SUBDIVISION REPORT - CONCEPT/USE ON REVIEW

▶ **FILE #:** 10-SB-20-C
10-C-20-UR

▶ **SUBDIVISION:** RIVER POINTE

RIVER POINTE
CONCEPT PLAN / USE ON REVIEW

GENERAL LAYOUT
PLAN VIEW

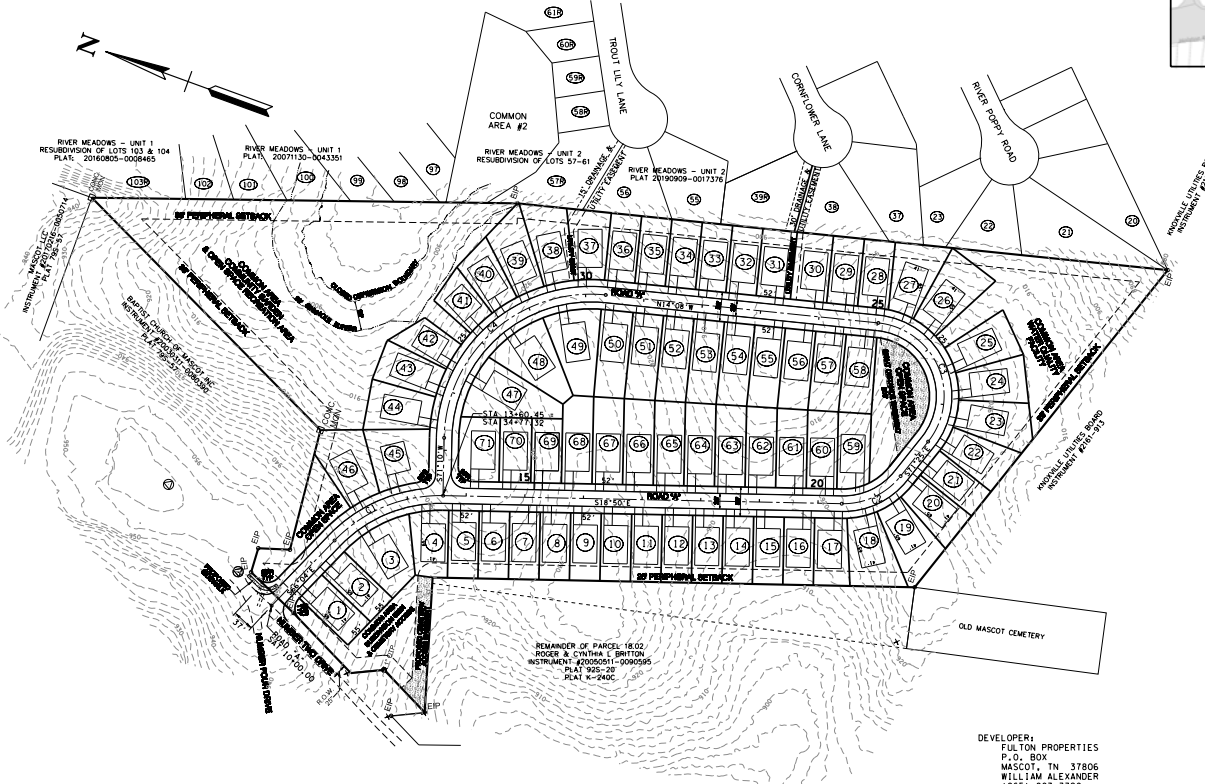
- 1) REDUCTION OF TANGENT LENGTH BETWEEN BROKENBACK CURVES ON ROAD 'A' FROM 150' TO 75.31'
- 2) REDUCTION OF INTERSECTION SPACING BETWEEN ROAD 'A' AND NUMBER FOUR DRIVE TO 37 FEET.

**STATION 21+02 FROM 250' TO 125'
2) REDUCTION OF MINIMUM CURVE RADIUS ON ROAD 'A' AT
STATION 24+59 FROM 250' TO 125'**

6. Providing a sight distance easement of 200 ft (centerline-to-centerline) across the common area lot adjacent to lots 58 & 59.
 7. Meeting all applicable requirements of the Knox County Department of Engineering and Public Works.

There is an open, usable common area located on the inside of the Road 'A' curve, adjacent to lots 58 & 59. There is no specified use for this common area. The common area in the northeast portion of the property with access shown between lots 41 & 42, is proposed as a "community garden and open space recreation area."

- **APPROVE** variances 1-2 and alternate design standard 1-2 based on the recommendations of the Knox County Department of Engineering and Public Works and because the site conditions restrict compliance with the Subdivision Regulations and the proposed variance will not create a traffic hazard.

APPROVE the Concept Plan subject to 10 conditions.

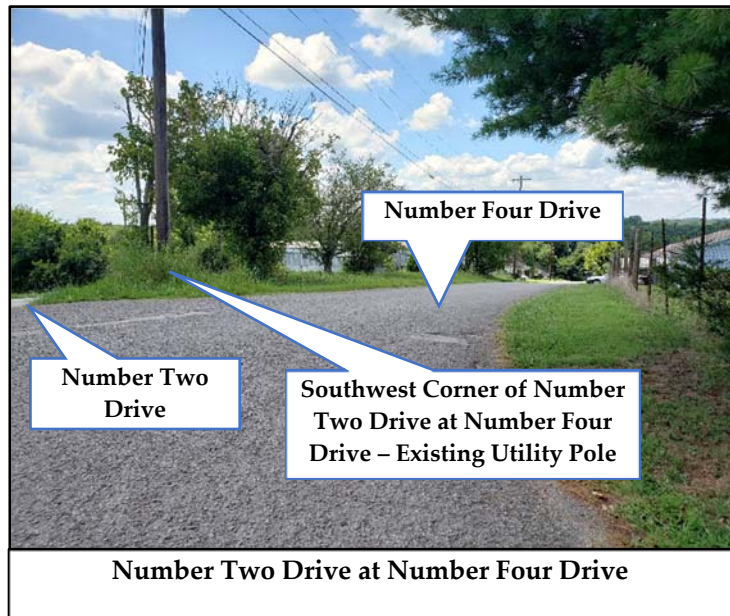
- 1b) Exclusive entering turn lanes are not recommended due to the low traffic volumes. The concept plan shows Road "A" tying into Number Two Drive roughly opposite of Number Four Drive and will create a skewed 4-way intersection.

intersect Number Two Drive slightly to the south of the centerline of Number Four Drive, which would make thru movements from Number Four Drive to Road "A" difficult. However, it is not expected that any motorists will make this maneuver. It is not recommended or warranted to provide additional pavement at the southwest

corner of Number Four Drive and Number Two Drive. A utility pole would need to be moved if pavement were added in this intersection corner.

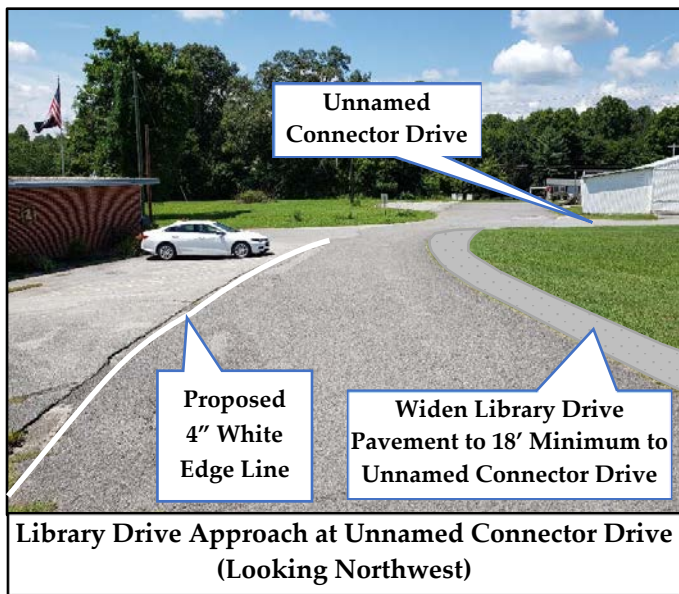
- 1d) Sight distance at the new proposed Road "A" at Number Two Drive intersection must not be impacted by new signage, future landscaping, or existing vegetation. The existing site has a utility pole and an arborvitae tree to the north of the proposed subdivision entrance location. The utility pole may need to be removed for the

construction of the entrance, and the tree will need regular maintenance in the future to not interfere with sight distance to the north. Based on a speed limit of 25-mph on Number Two Drive, the required Intersection Sight Distance (ISD) is 250 feet. On the southbound approach of Number Two Drive at the proposed Road "A" intersection, the SSD is calculated to be 155 feet. On the northbound approach of Number Two Drive at the proposed Road "A" intersection, the SSD is calculated to be 140 feet. These distances should be verified in the design plans and must be verified by a licensed land surveyor in the field. These distances must be met to ensure safe operations.

- 1e) It is recommended that the Road "A" entrance approach at Number Two Drive be designed and constructed with a 24" white stop bar and a Stop Sign (R1-1). The stop bar should be applied at a minimum of 4 feet away from the edge of Number Two Drive and should be placed at the desired stopping point that provides the maximum sight distance.

View of Number Two Drive Approach from Tipple Drive (Looking East)

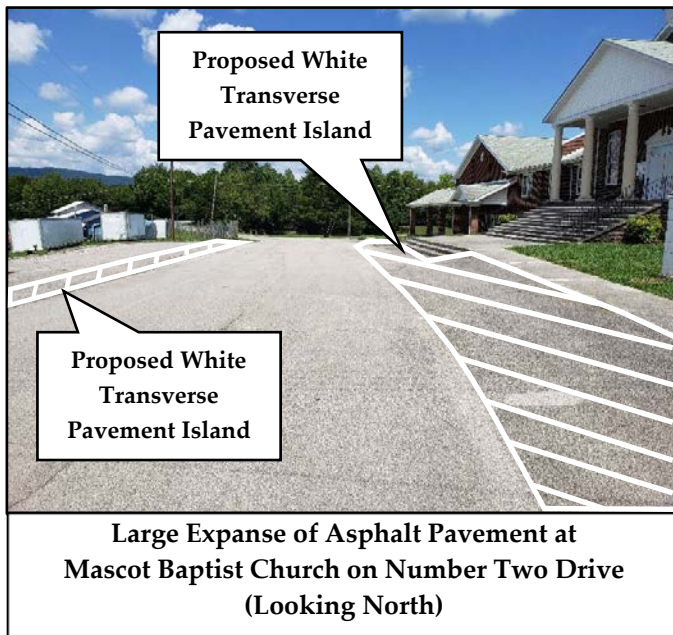
- * 2g) The intersection of Number Two Drive at Tipple Drive currently operates as a quasi-4-way intersection. The 4th leg of this intersection, the east approach, has an abrupt end and continues as a driveway to an undeveloped private property to the east. Currently, this approach has a set of cinder blocks and wood posts for a road barrier. In actuality, this intersection operates as a 3-way intersection

with the southbound Number Two Drive approach operating under stop conditions with a Stop Sign (R1-1). However, during the field review, very few motorists were observed coming to a stop. Most of the observed motorists completed rolling stops.

Due to the low compliance rate, the County should consider removing this Stop Sign for this approach as it contributes to the disregard of Stop Signs. Since a more significant number of vehicles will be traveling northbound and southbound on Number Two Drive once the subdivision is developed, it is recommended that the stop condition be assigned to the Tipple Drive approach and allow Number Two Drive to operate freely. It is assumed that very few vehicles use the Tipple Drive approach at Number Two Drive. With the increase northbound

and southbound travel combined with the reduced sight distance from Tipple Drive looking to the south, it is recommended that a Stop Sign (R1-1) and a 24" white stop bar be installed on the Tipple Drive approach. Sight distance to the south is reduced from Tipple Drive due to the placement of the private garage/warehouse on the southwest corner of the intersection.

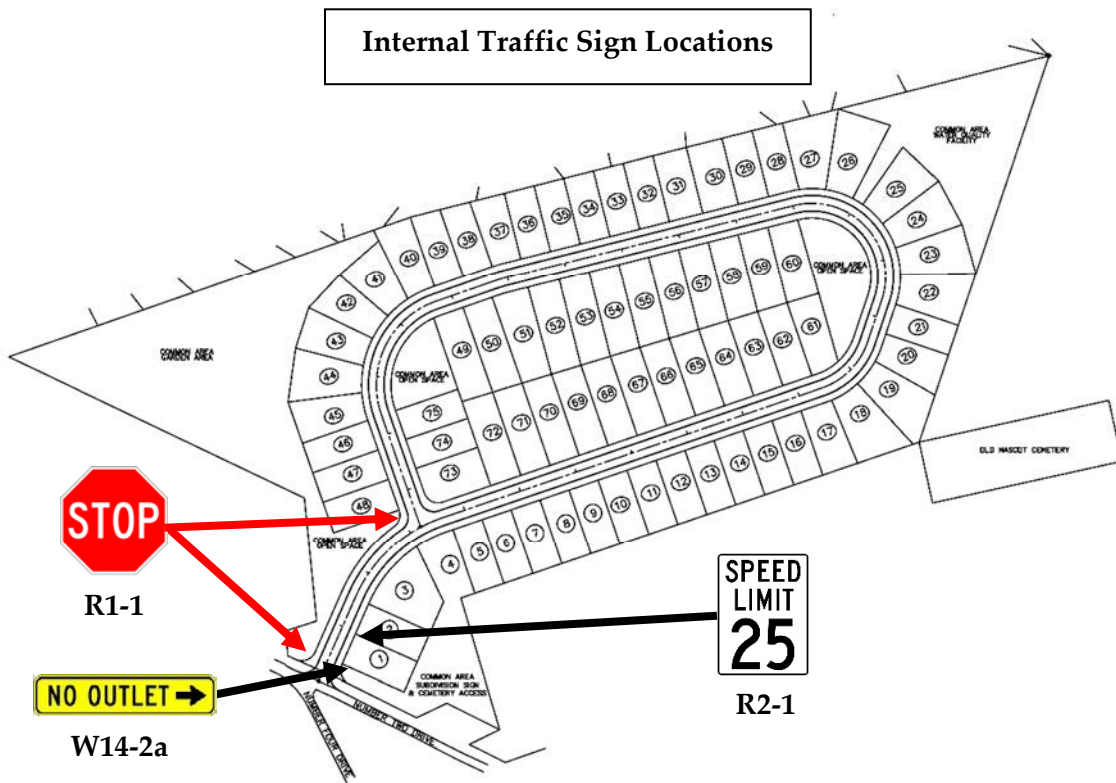
River Pointe Subdivision Internal Roads: The current concept plan shows one new looped street being constructed within the development, as shown in Figure 3.

- 3a) It is recommended that a “No Outlet” Sign (W14-2a) be posted at the front of the subdivision on Road “A”. This sign can be posted below the street name sign. A 25-mph Speed Limit Sign (R2-1) should also be posted at the beginning of Road “A”.
- 3b) Stop Signs (R1-1) with 24” white stop bars and the other traffic signage should be installed at the locations as shown below:

- 3c) Sight distance at the new internal intersections in the subdivision must not be impacted by new signage or future landscaping. For a posted speed limit of 25-mph in the subdivision, the intersection sight distance requirement is 250 feet. The stopping sight distance required is 155 feet for a level road grade. The road layout designer should ensure that these sight distance lengths are met, and they should be labeled on the plans.
- 3d) All drainage grates and covers for the residential development need to be pedestrian and bicycle-safe.

FIGURE 9
River Pointe Subdivision
Summary of External Recommendations

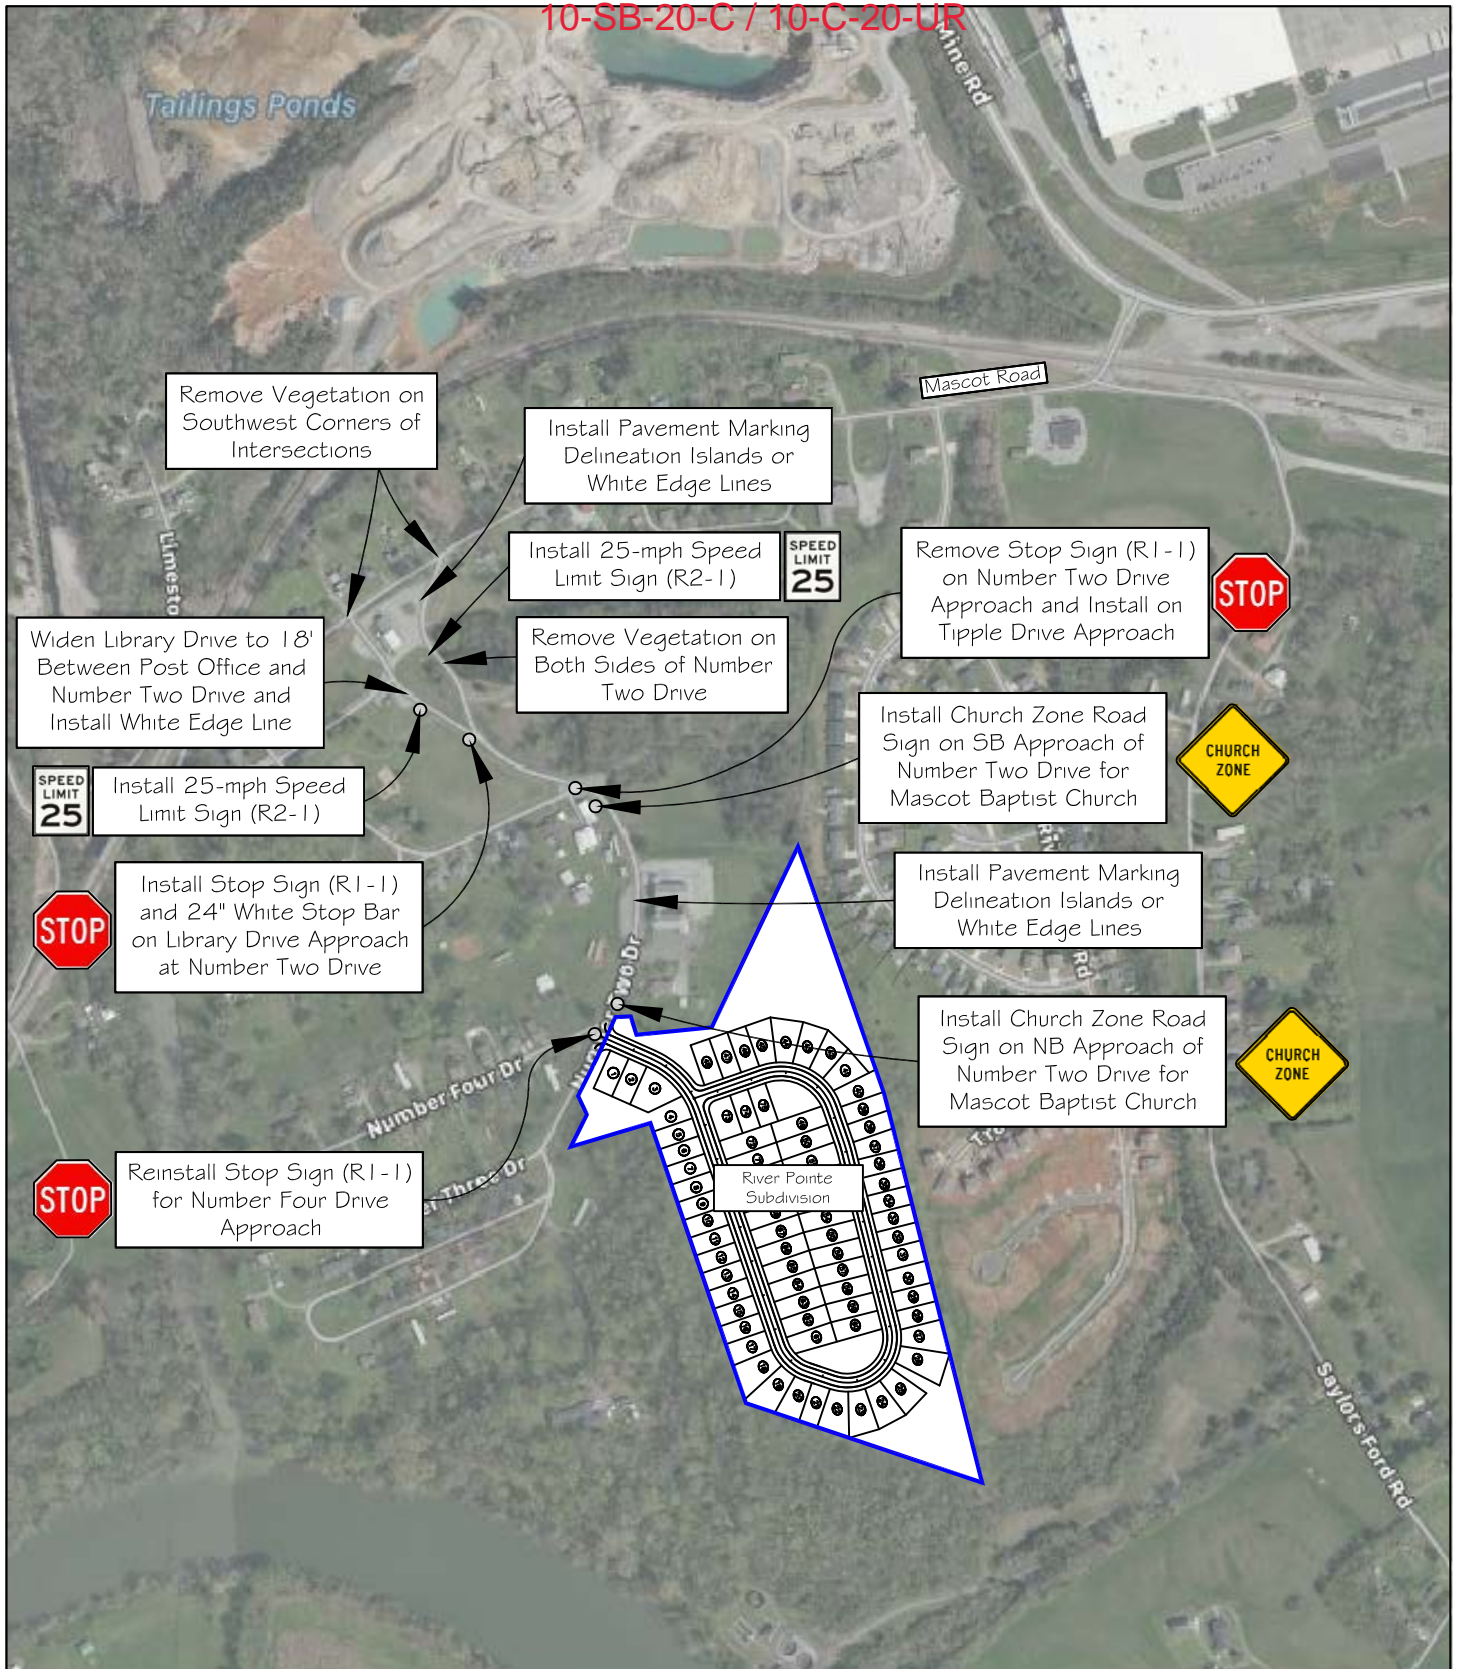
The following is an overview of recommendations to minimize the transportation impacts of the proposed development on the adjacent road system while attempting to achieve an acceptable level of traffic flow and safety. A summary of the recommendations is provided at the end of this section in Figure 9. The recommendations marked with an asterisk indicate an existing need and are not associated with the projected transportation impacts of the proposed subdivision.

5. Implementation of the road improvement recommendations outlined in the Transportation Impact Study (TIS) prepared by Ajax Engineering (September 18, 2020), as revised, and reviewed and approved by Planning Commission staff and Knox County Engineering and Public Works. The design details and timing of the installation of the improvements shall be worked out with the Knox County Department of Engineering and Public Works during the design plan stage for the subdivision and the required road improvements shall be completed prior to approval of the final plat for the subdivision.
